**DISTRICT OF COLUMBIA DEPARTMENT OF MENTAL HEALTH
CONTRACTS AND PROCUREMENT ADMINISTRATION**

**REQUEST FOR QUOTE TO PROVIDE AND INSTALL A NEW COOLING SYSTEM AT
SAINT ELIZABETHS HOSPITAL, RMB BUILDING TRANSFORMER, ELECTRICAL AND
SWITCHGEAR ROOMS**
RM-09-RFQ-193-BY0-RKG

AMENDMENT NUMBER ONE (1)

1 SWITCHGEAR ROOM COOLING 1/8"=1'-0"

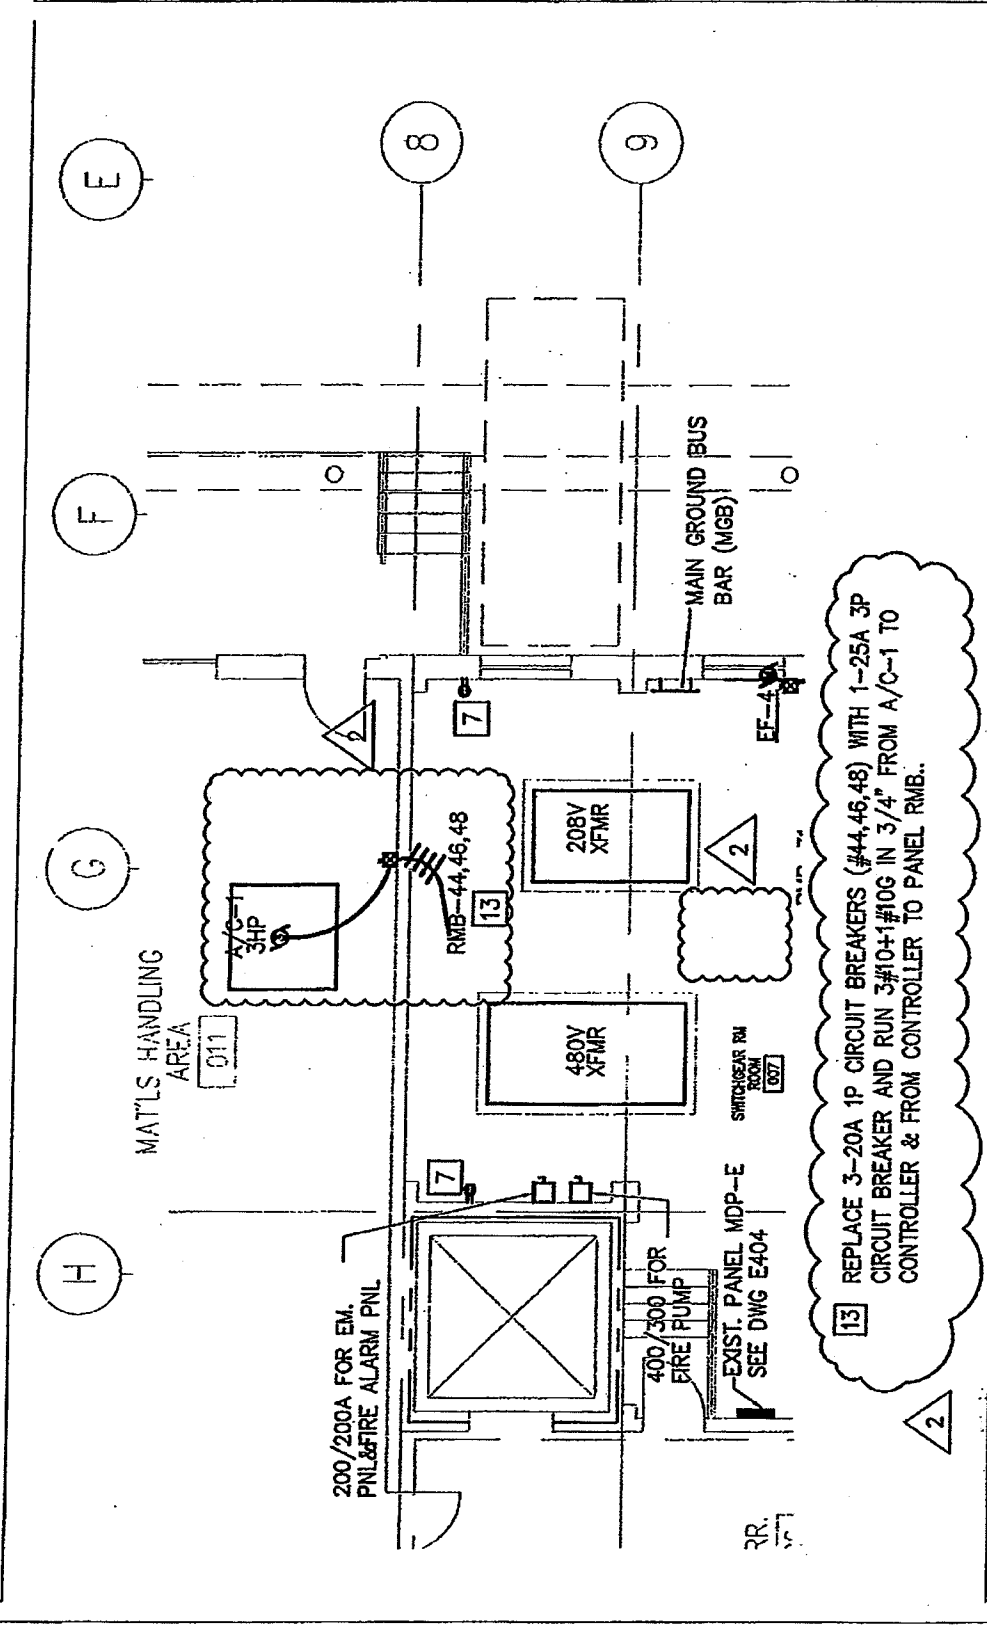
Question No.	RFP Section	Question
1	Section C.2	The above mentioned RFQ (RM-09-RFQ-193-BY0-RKG) mentions an attached diagram in Section C.2. Kindly make this diagram available on the website at the earliest.
<p>DMH RESPONSE: Section C.2, bullet 3, is amended to include the diagram below as follows:</p> <ul style="list-style-type: none">• Provide and install one (1) 1,200 CFM fan coil unit with associated duck work and piping in the switchgear room in the RMB building as per the diagram below:

13 REPLACE 3-20A 1P CIRCUIT BREAKERS (#44, 46, 48) WITH 1-25A 3P CIRCUIT BREAKER AND RUN 3#10+1#10G IN 3/4" FROM A/C-1 TO CONTROLLER & FROM CONTROLLER TO PANEL RMB.
